FROM: Northern States Power Co. Minneapolis, Minnesota 55401 A. V. Dienhart		DATE OF DOC NONE	DATE REC'D 3-20-74	LTR	MEMO	RPT	OTHER
TO:		ORIG	CC	OTHER	SENT AEC PDR <u>X</u>		
		NO ORIG			SENT LOCAL PDR <u>X</u>		
CLASS	UNCLASS XXXXX	PROP	INPUT	NO CYS REC'D 0	DOCKET NO: 50-263		
DESCRIPTION: No Ltr of trans rec'd.....				ENCLOSURES: Response to AEC Questions on Monticello High Energy Line Breaks Outside of Containment			
ACKNOWLEDGED				DO NOT REMOVE			
PLANT NAME: Monticello				(40 cys rec'd)

RESPONSES TO AEC

QUESTIONS ON MONTICELLO HIGH ENERGY
LINE BREAKS OUTSIDE OF CONTAINMENT

In order to provide protection to the mezzanine floor against pipe whip, four restraints will be added. Detail drawings of the pipe restraints are attached. The design load for the pipe restraint was 161 kips.

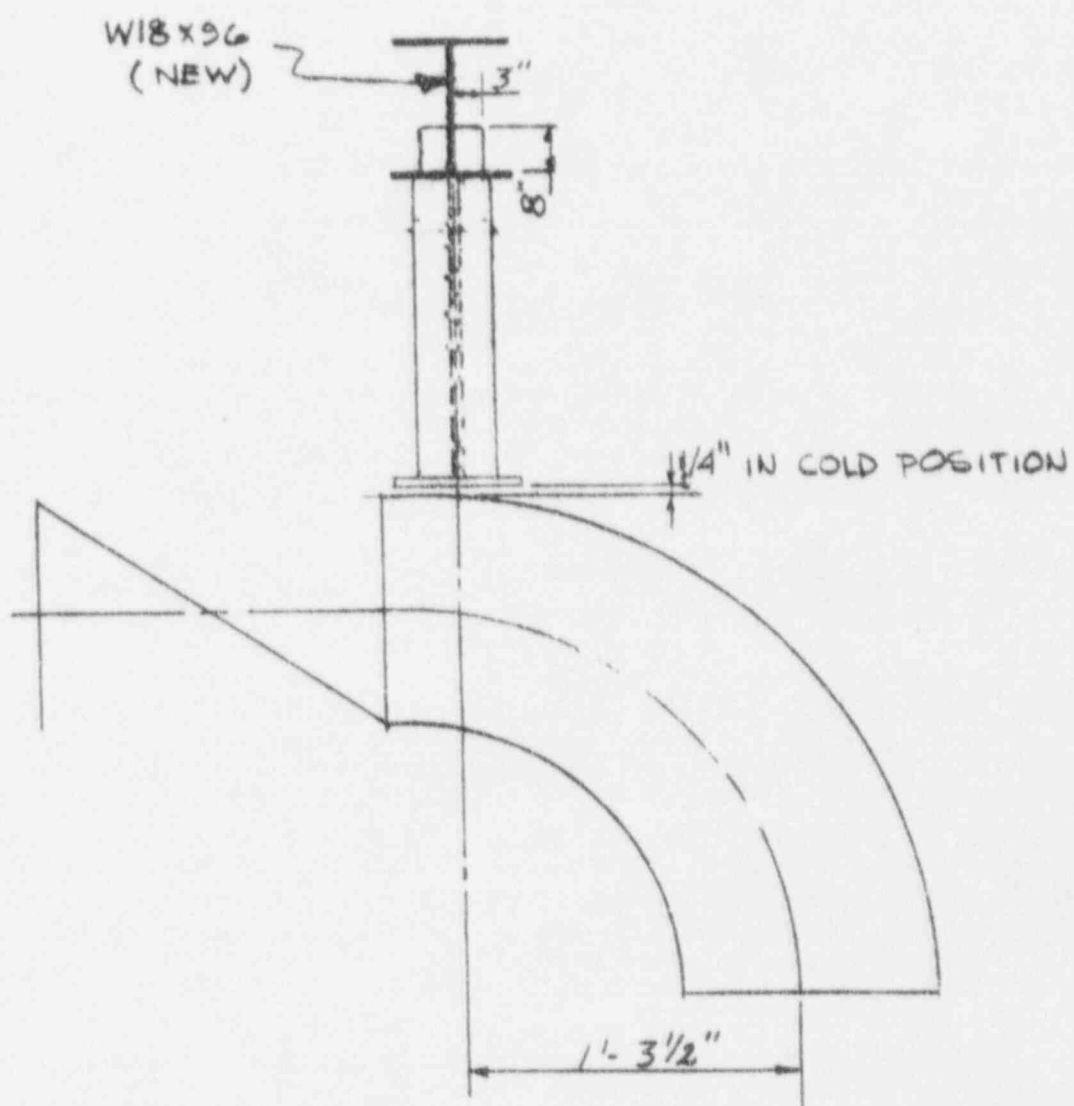
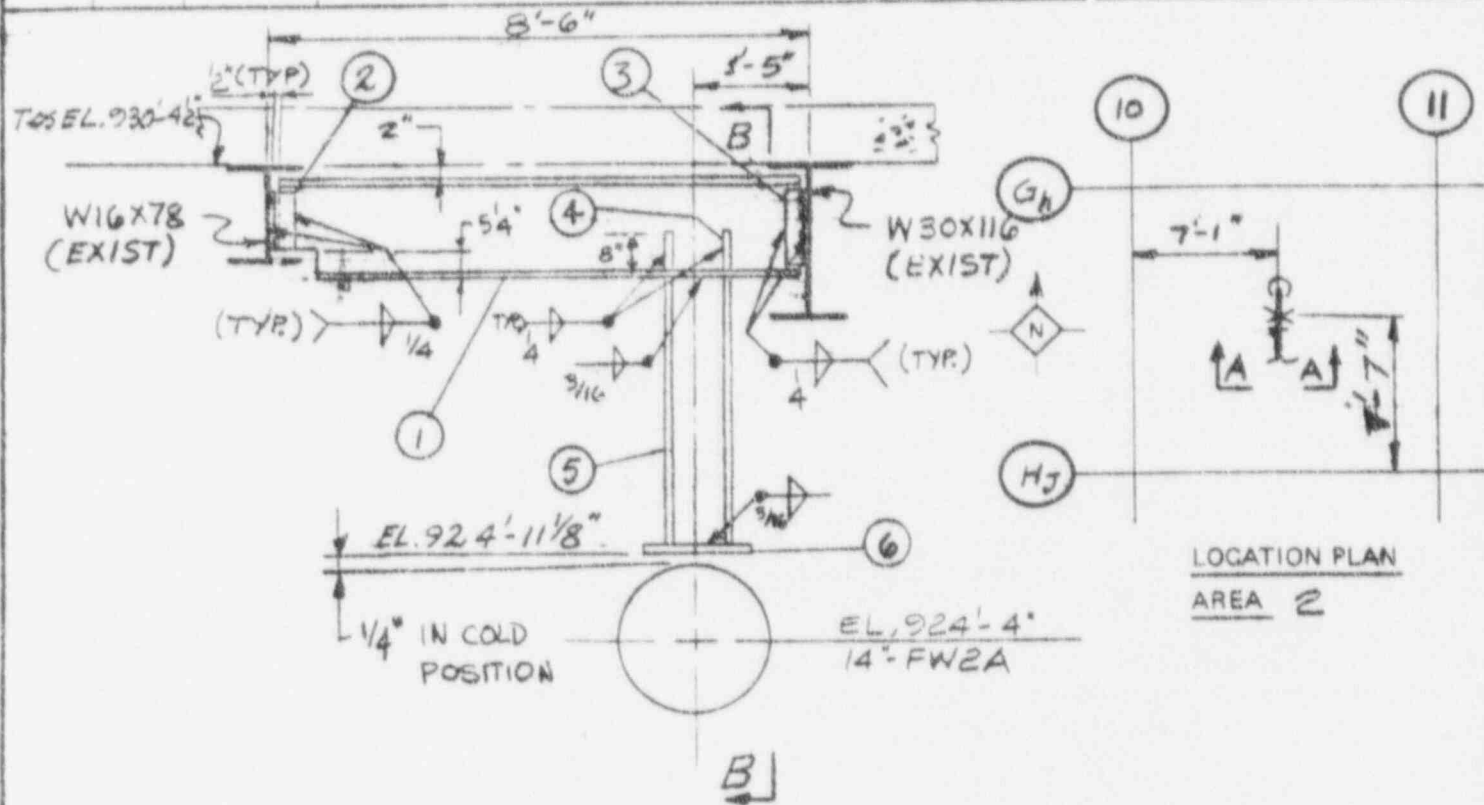
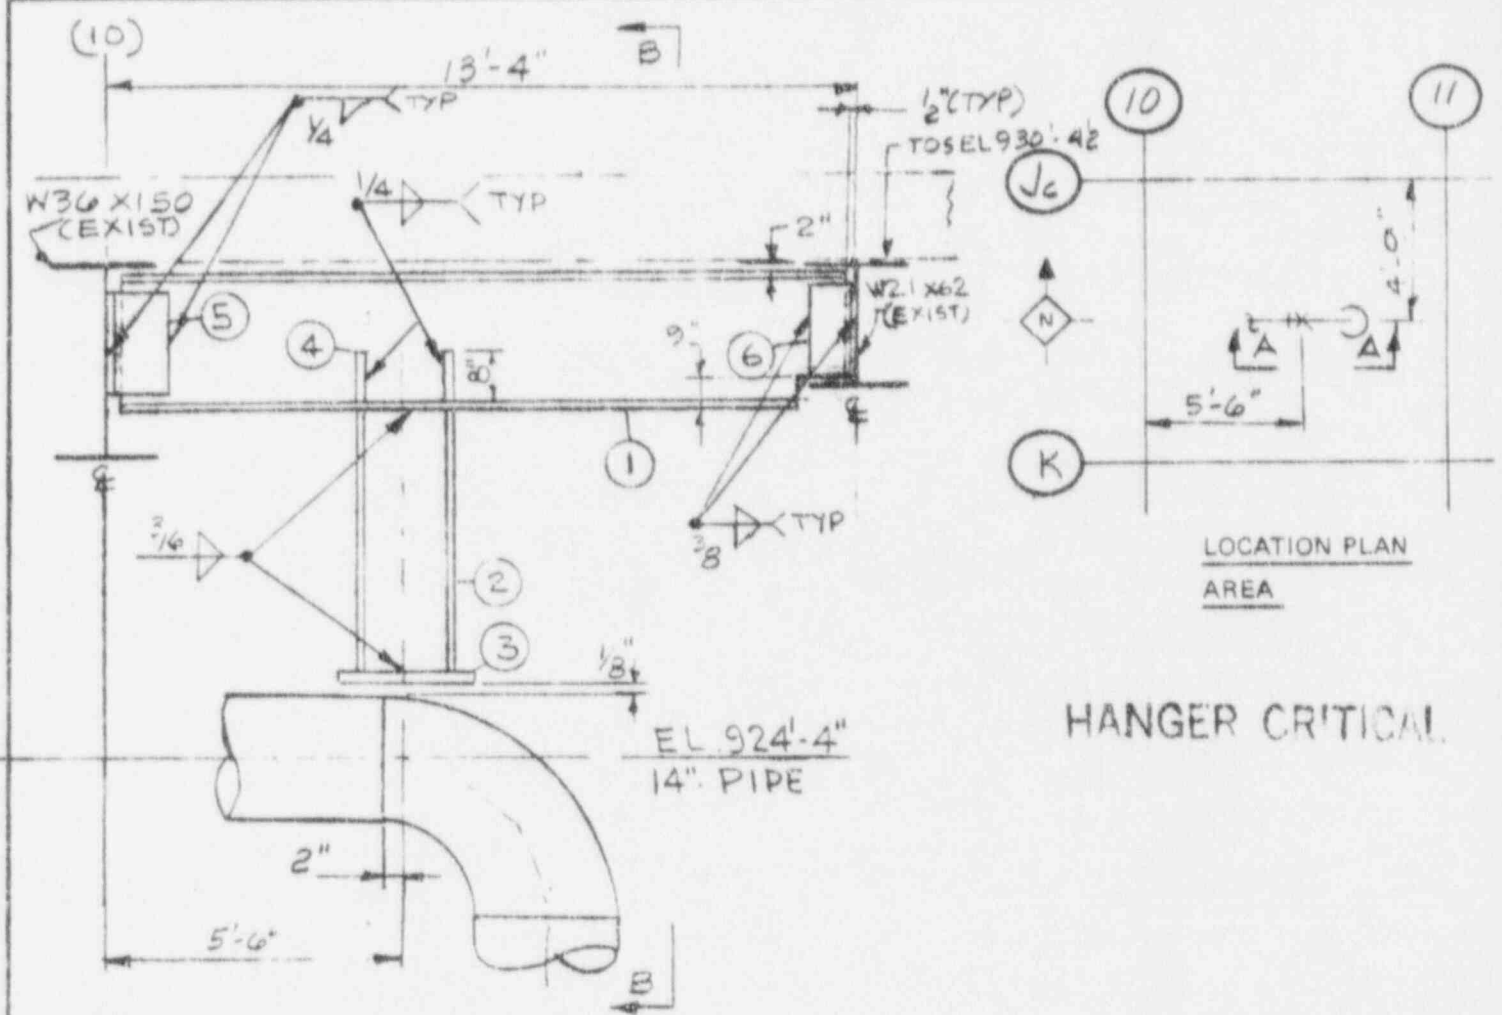
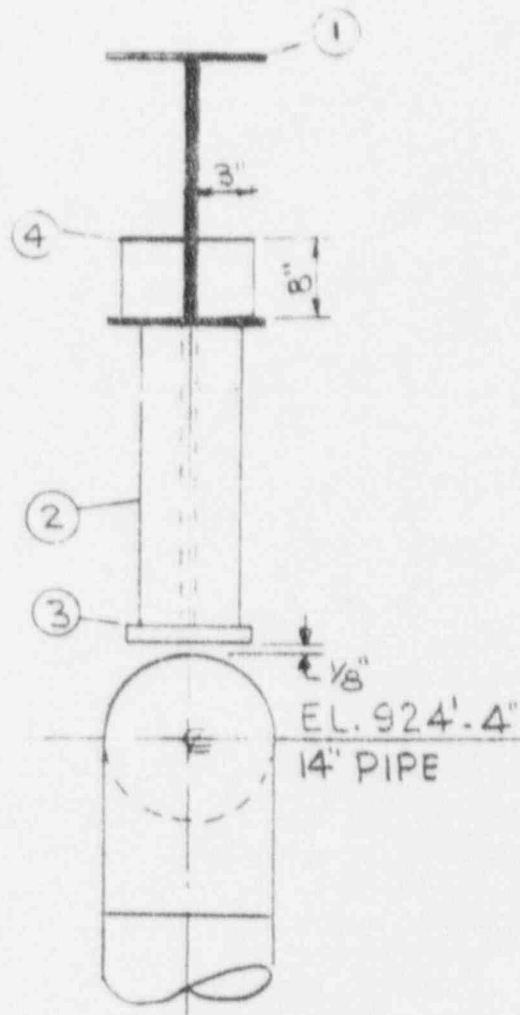
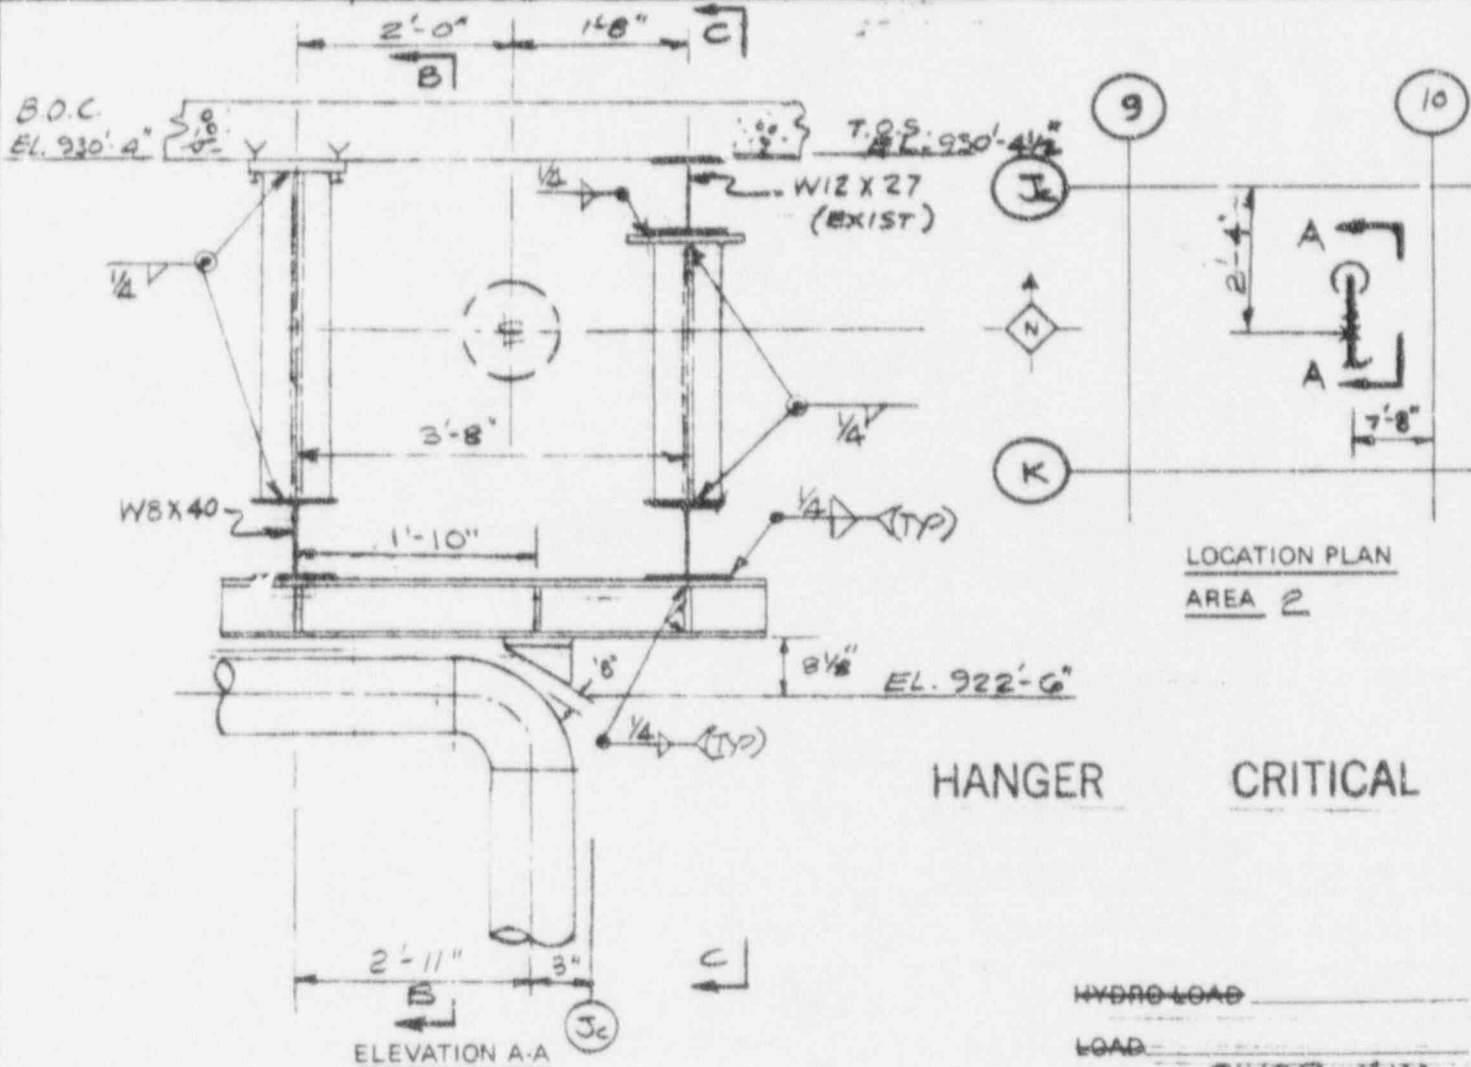
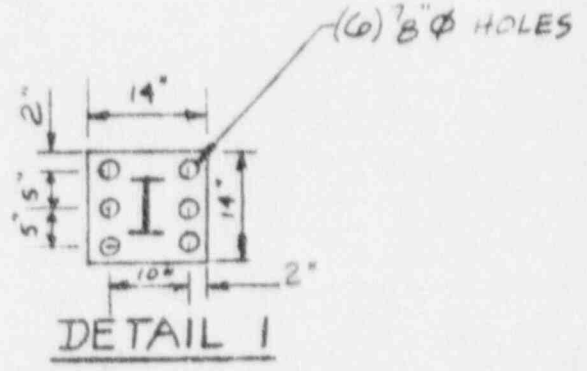
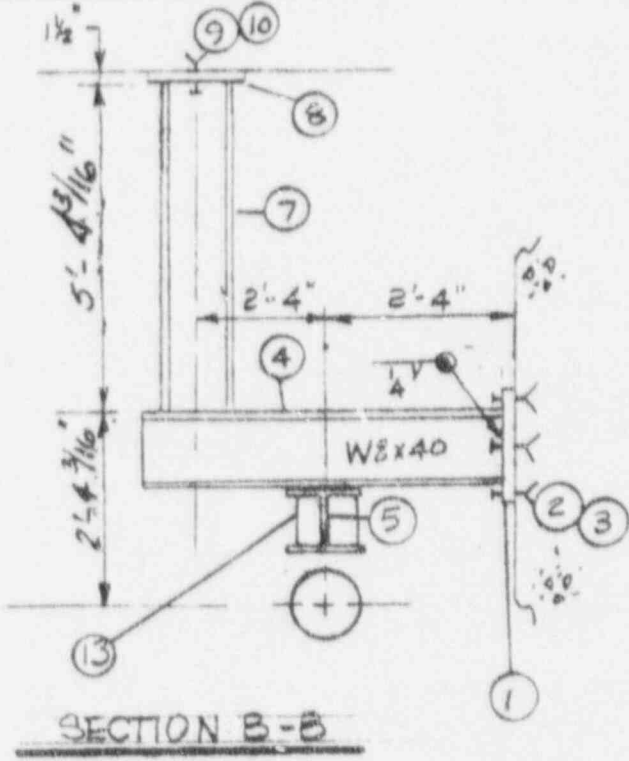
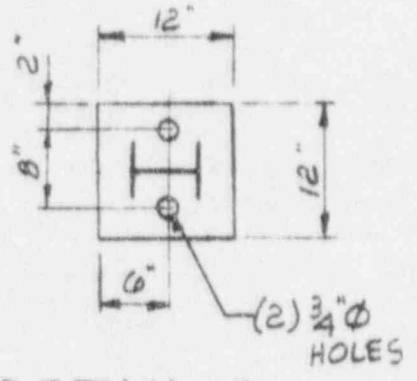
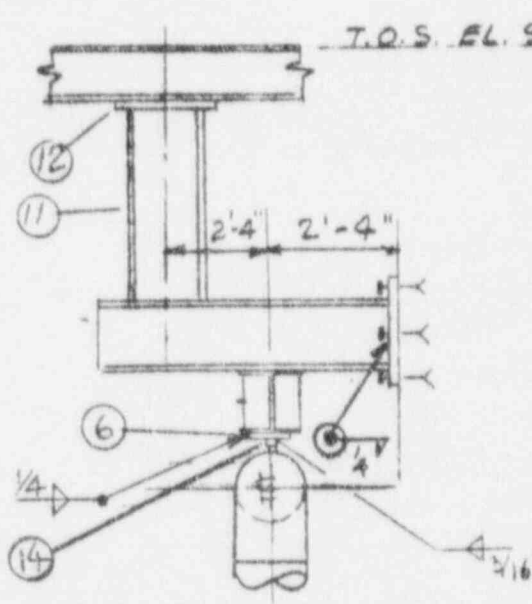
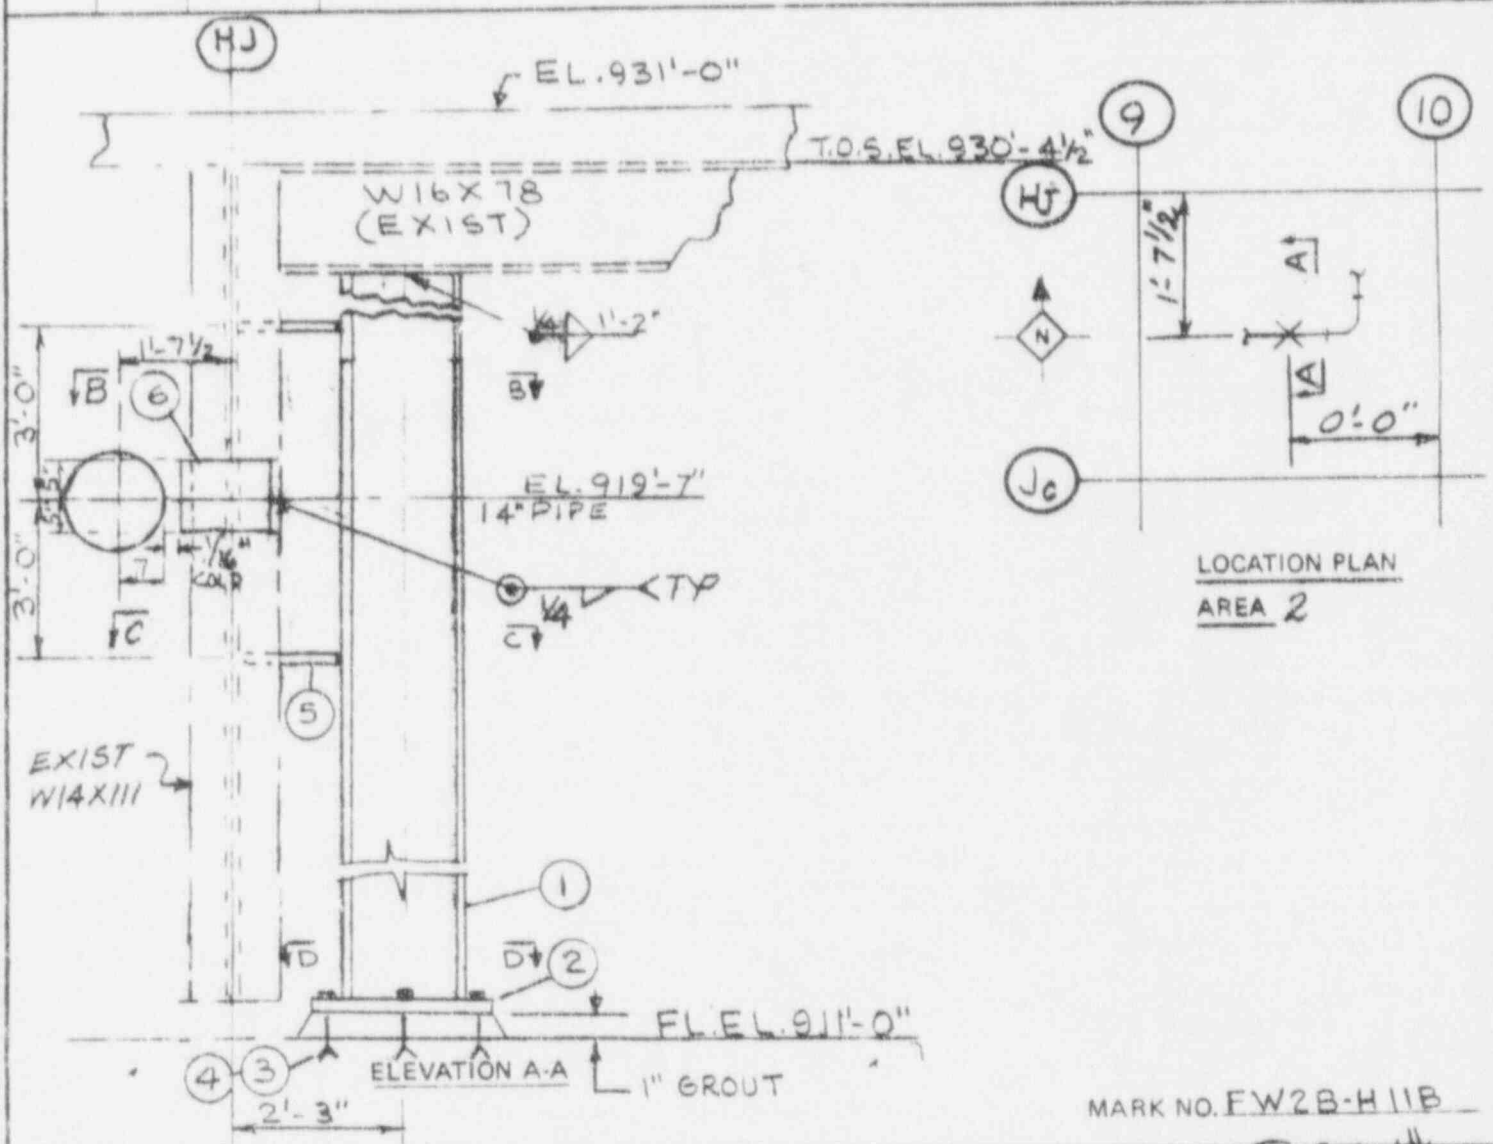
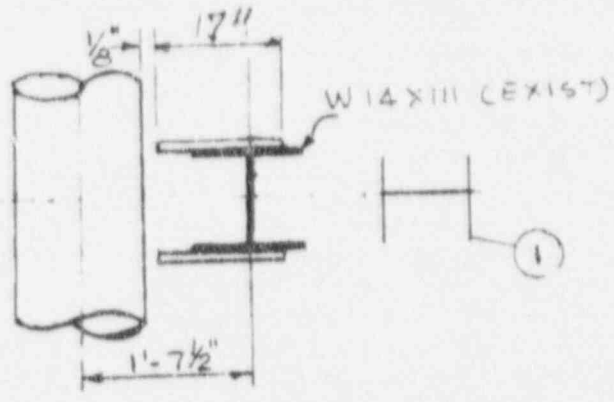
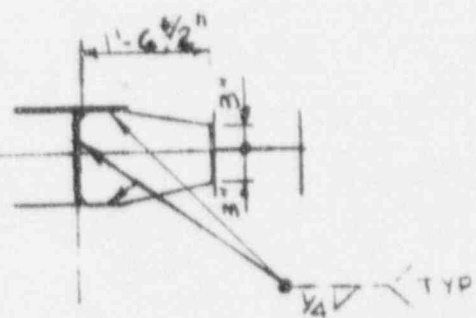
3. QUESTION: Submit details of the additional protection mentioned in paragraph 6.2.2(1).

ANSWER: The additional protection envisioned at the time of the report was a plate protecting the turbine building mezzanine floor (elevation 931'0") from a jet of water impinging on the floor. This would also have provided pipe whip protection. Further analysis of the break and break locations resulted in the following:

b. Pipe Whip

With the addition of the four pipe restraints, the mezzanine floor will be protected; thereby insuring safe shutdown of the plant following a feedwater line break.
